Westinghouse
Electric Corporation

NTD-NRC-94-4337
DCP/NRC0242
Docket No.: STN-52-003

SUBJECT: WESTINGHOUSE RESPONSES TO NRC REQUESTS FOR ADDITIONAL
INFORMATION ON THE AP600

NTD-NRC-94-4337
ATTACHMENT A
AP600 RAI RESPONSES
SUBMITTED NOVEMBER 11, 1994

Figure 231.26-1
2D SASSI Analysis, E-W Direction
Parabolic Soil Profile Evaluation

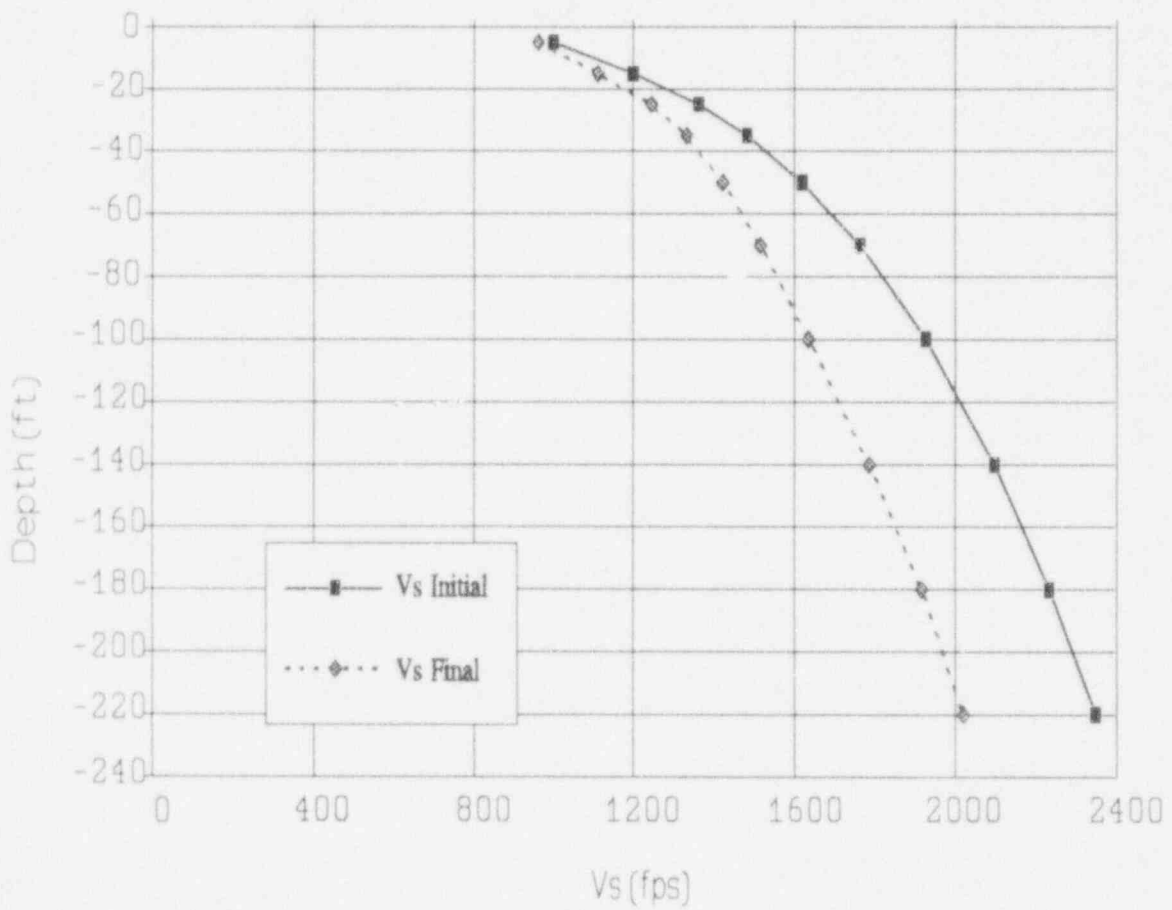
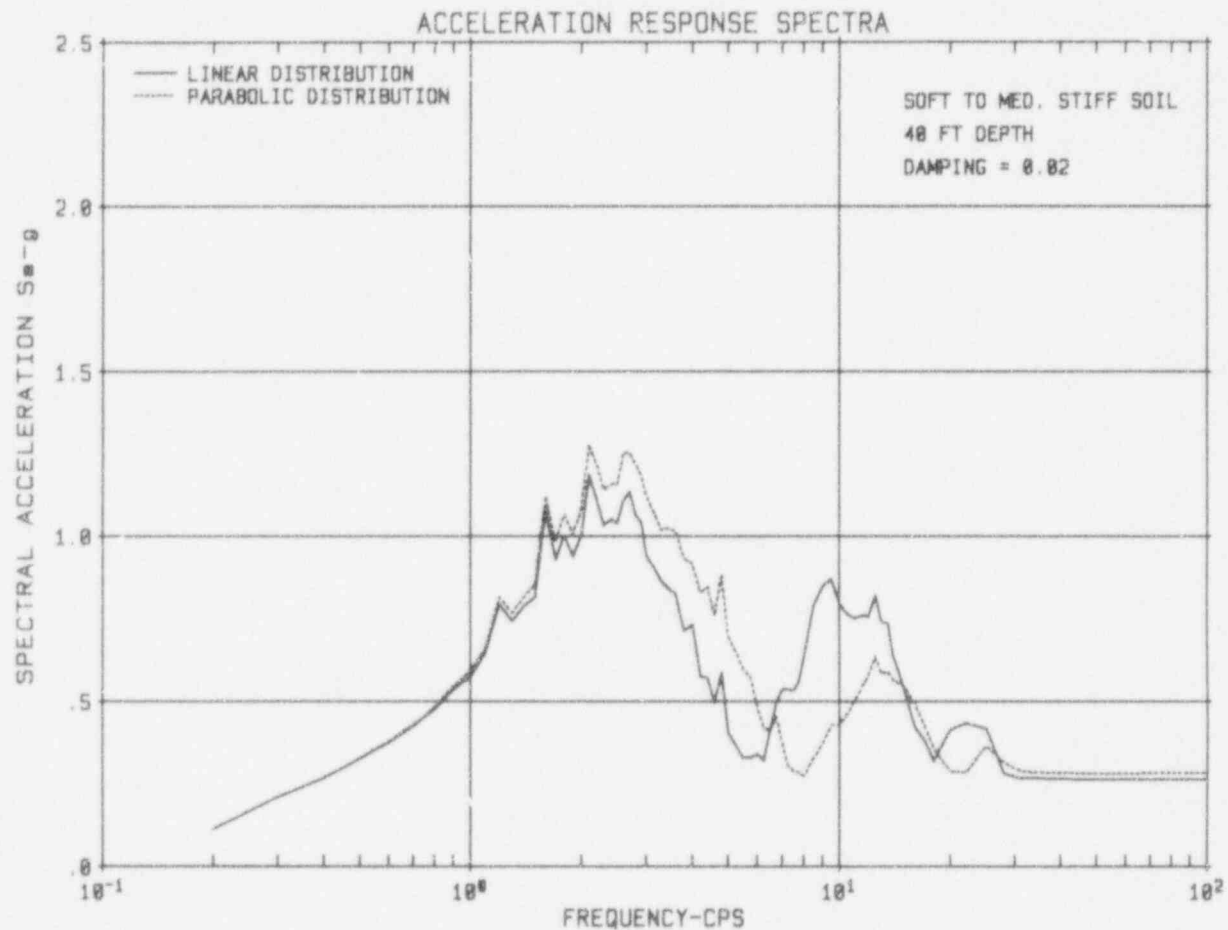
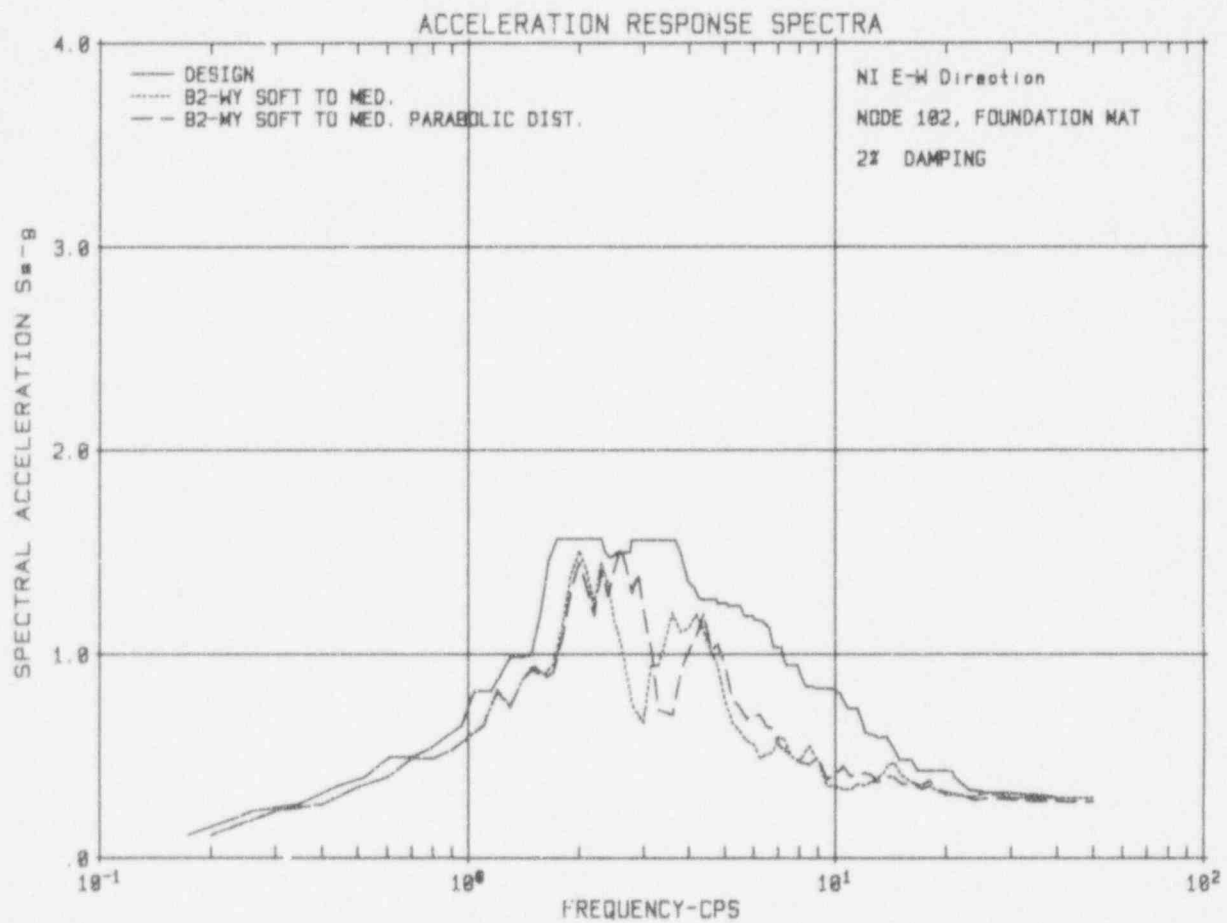
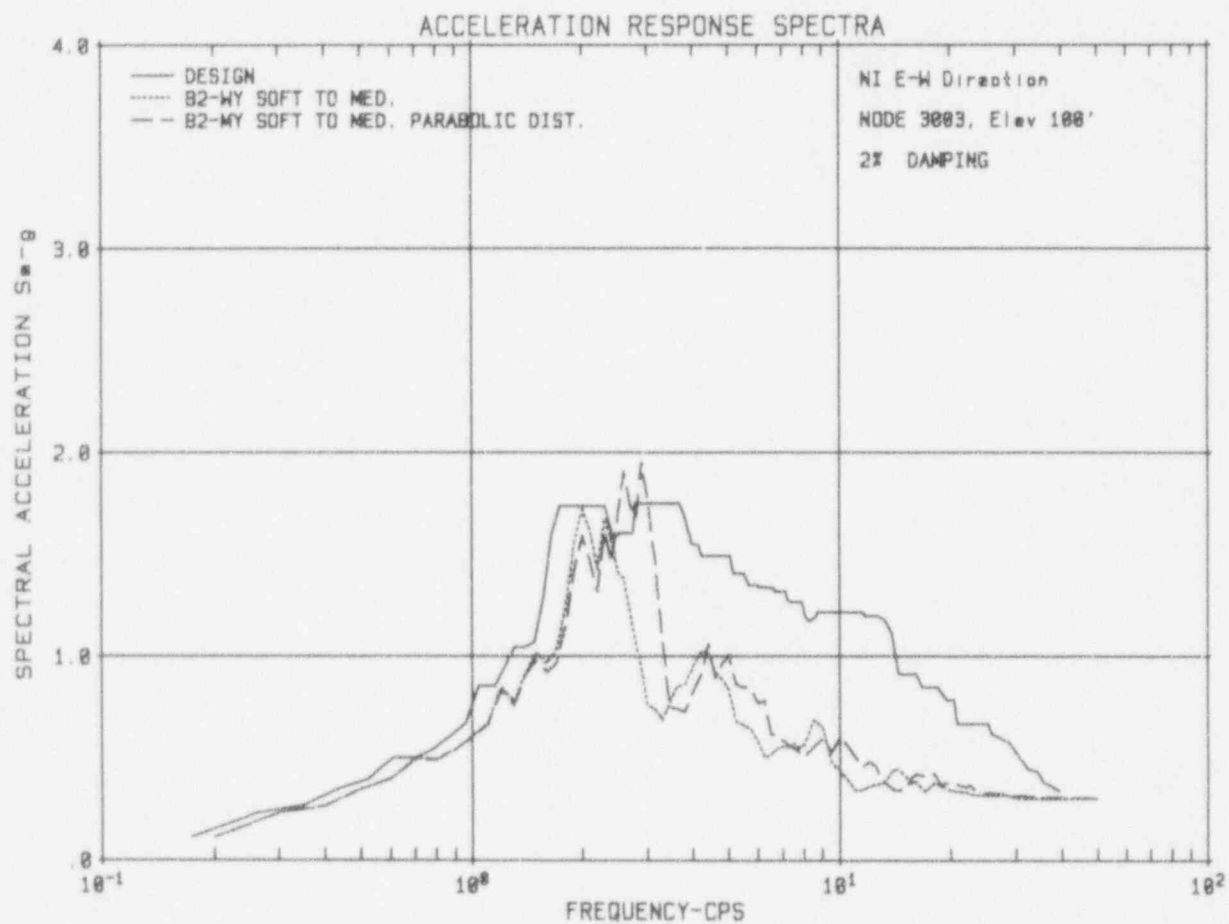
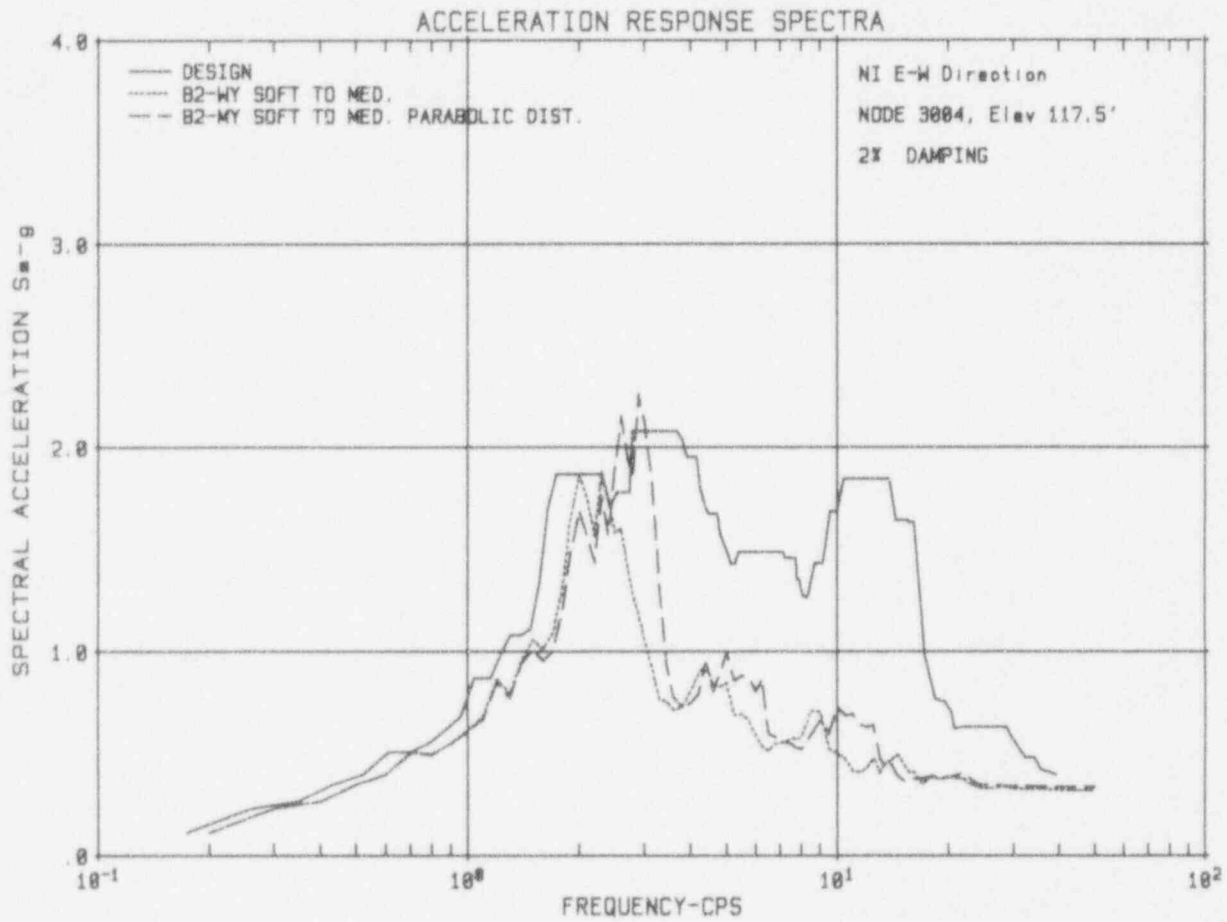
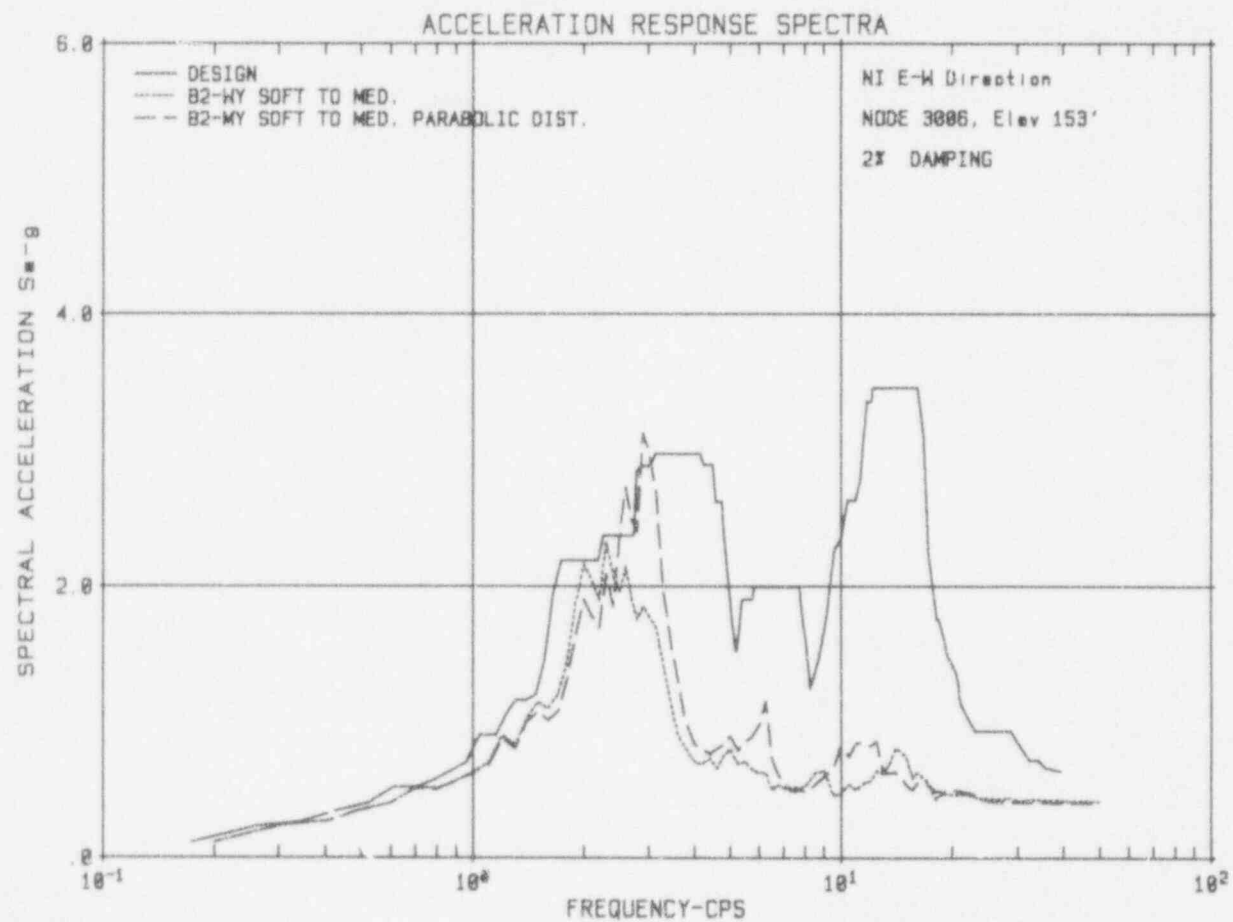
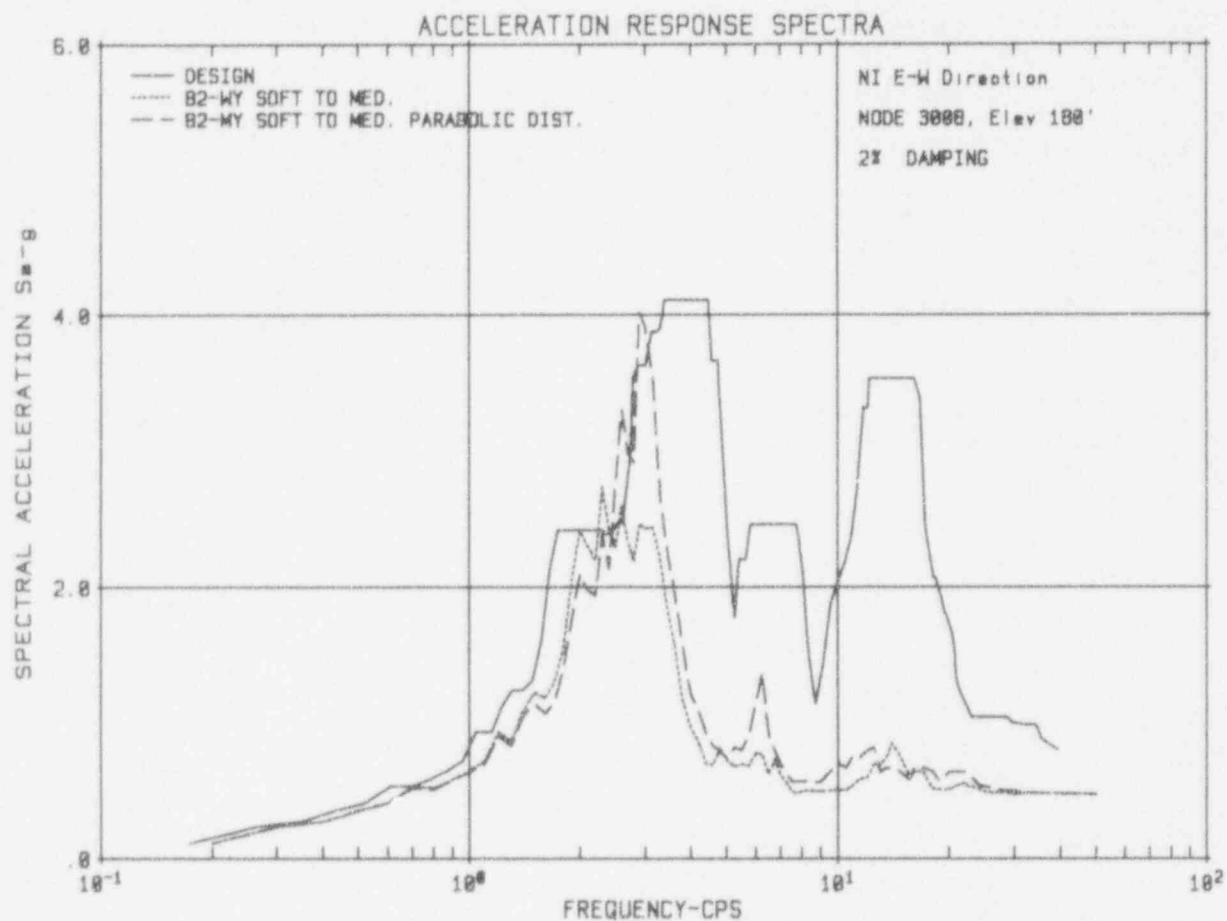
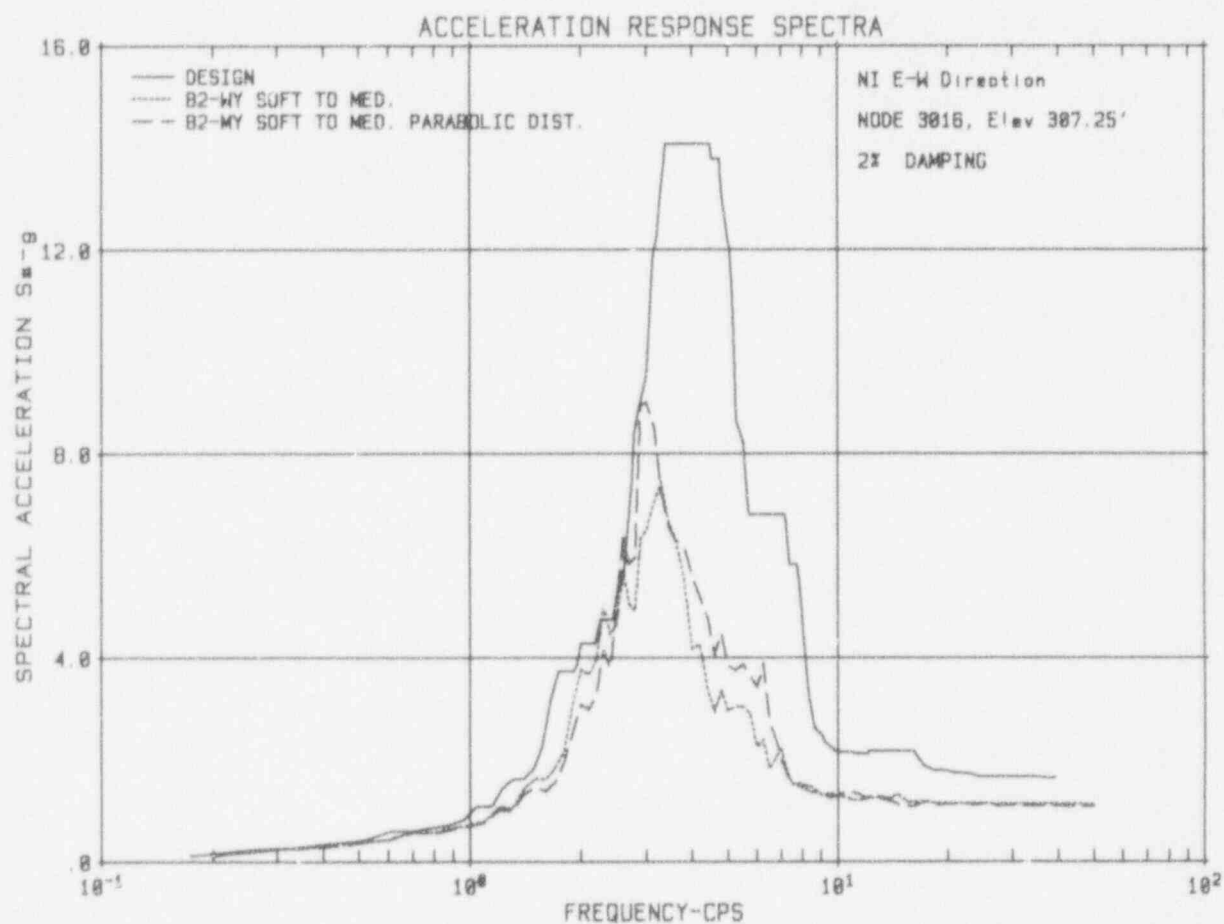
The properties of the soft-to-medium soil column given in Table 2A-6 of the SSAR show the shear wave velocity varying linearly from 1000 fps to 2400 fps. Typical variations at sandy soil sites are expected to be curvilinear, with most of the increase in soil stiffness occurring near the upper one-third part of the soil layer due to the nonlinear effects of depth of burial on stiffness. Because such variations may lead to significant differences in soil pressures over the depth of embedment of the NI, as well as changes in free-field ground motions at the foundation mat, provide a comparison of free-field motions at the foundation level obtained from SHAKE deconvolution analysis to indicate the sensitivity of response to this assumption.

The case of soft-to-medium soil with shear wave velocity of 1000 ft/sec at grade level increasing to 2400 ft/sec at 240 ft depth with parabolic distribution was analyzed. The maximum low-strain shear wave velocity and the strain-compatible velocity obtained from the SHAKE analysis, using the 1990 Idriss soil strain degradation curve described in the response to RAI 230.79, are shown in Figure 231.26-1. The response spectra of the free-field motion at 40 ft depth (foundation mat elevation) corresponding to parabolic and linear distribution of shear wave velocity case are compared in Figure 231.26-2. As shown in this figure, the response motion using parabolic velocity distribution shows small variations above and below that of the linear velocity distribution depending on the frequency. In order to study the effect of parabolic velocity distribution on the SSI responses, the SSI model in the EW direction was re-analyzed. In this case, the water table was considered at the grade level and the base rock was modeled at 120 ft depth. The strain-compatible properties obtained from the SHAKE analysis were used in the SSI analysis.

The SSI responses of this case are compared with the SSI responses of the same case with linear velocity distribution and enveloping design responses obtained from 3D analysis in Figures 231.26-3 through 231.26-13. These comparisons show that the responses with the parabolic distribution are generally similar to those with the linear distribution and enveloped by the design response spectra obtained for the 3D analyses. There is additional rocking of the nuclear island at a frequency of 3 Hertz which also results in higher peaks at this frequency for the containment internal structures (CIS) and the steel containment vessel (SCV). This increase at the 3 Hertz frequency is attributable to a combination of the following:

- The seismic input at the foundation level is higher for the parabolic distribution as shown in Figure 231.26-2.
- The stiffer soil properties for the parabolic distribution increase the rocking frequency for the nuclear island. This increased stiffness shifts the response closer to that of the soft rock. A comparison of the responses from the 3D design analyses are provided in SSAR Figures 3.7.2-25, 3.7.2-26 and 3.7.2-27.
- The H2 seismic input has significant frequency content at 3 Hertz. This is shown in SSAR Figure 3.7.1-7.

The design soil profile used for the 3D SASSI design analyses for the soft-to-medium soil case will be revised to the parabolic profile using the 1990 Idriss soil strain degradation curve. As shown in the figures, this will amplify the responses at about 3 Hertz and slightly reduce the responses at 2 Hertz. The revised analyses will be documented in the SSAR by July, 1995.
